Abstract of New TEPRI (TEPRIa) development

We will produce new TEPRI (TEPRIa). The main reason is that Falc2254 is substituted by Falc2256. Because Falc2254 that is current framer will not be continued any more in stock, and some more Hardware parts(CPU, DRAM, Flash Rom, DP-RAM, CPLD) are changed. So software should be changed to support the new configuration but, call processing, signaling, MMC setting, line cabling and functional parts will be same as current TEPRI.

Figure 7

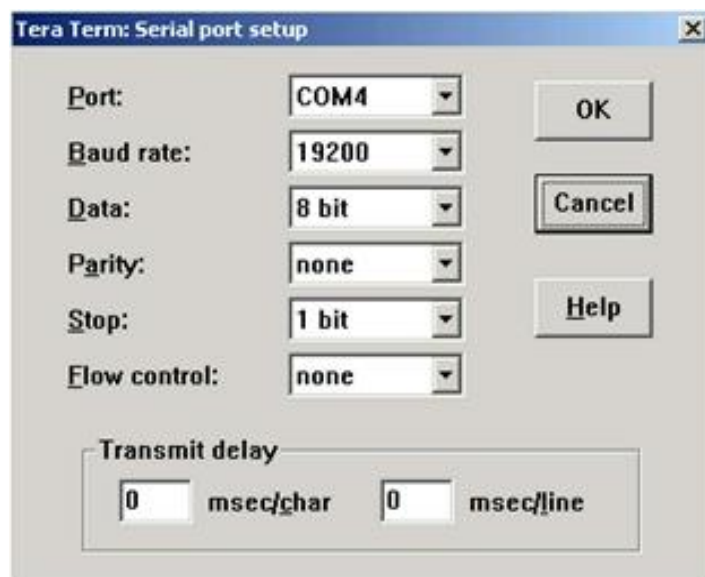
SIO port is changed to RJ-45 from DB-9 port. That is only thing to be changed. Using method is same as before. You can refer to the below picture.
